DESIGN KE	DRAWN BY [Signature]	DART AEROSPACE LTD HAWKESBURY, ONTARIO, CANADA	
CHECKED [Signature]	APPROVED [Signature]	DRAWING NO. DSI 9115	REV. A 1 OF 1
DATE 98.11.18	TITLE BAGGAGE DOOR LATCH KIT		SCALE NTS
A	98.11.18	NEW ISSUE

DART SERVICE INSTRUCTION

AMEND INSTALLATION DRAWING D350-588 REV. B AND D350-589 REV. B
STA: SH92-41
STC: SH1012NE

SECTION C-C AND E-E OF D350-588 REV. B
SECTION D-D OF D350-589 REV. B
SECTION C-C OF D350-589 REV. B MIRRORED

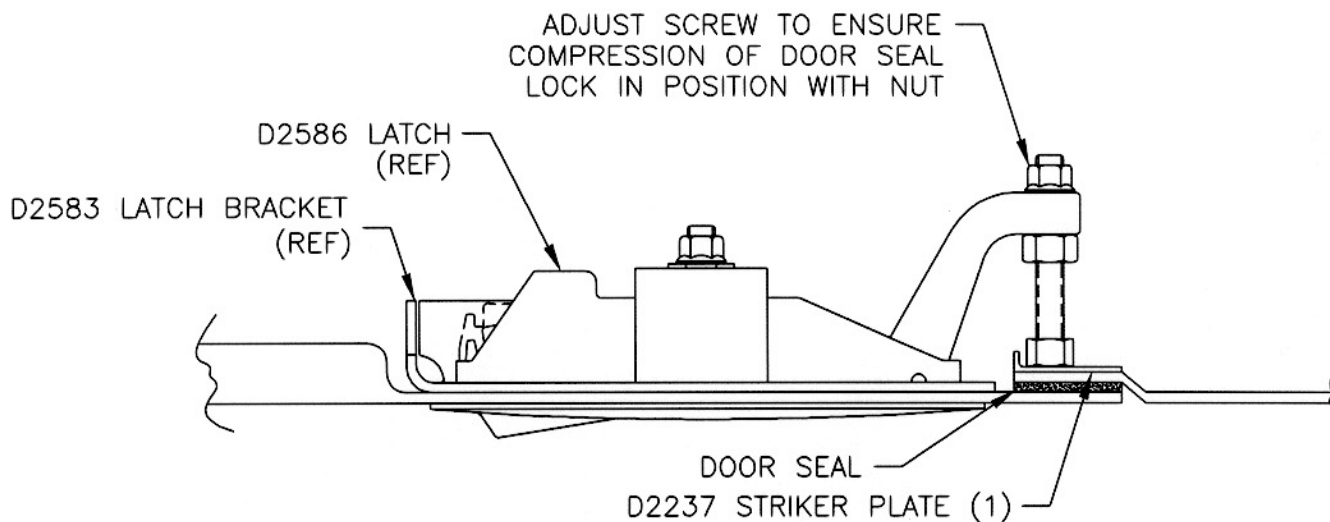
D2237 STRIKER PLATE & DOOR SEAL REVISED AS
ILLUSTRATED BELOW
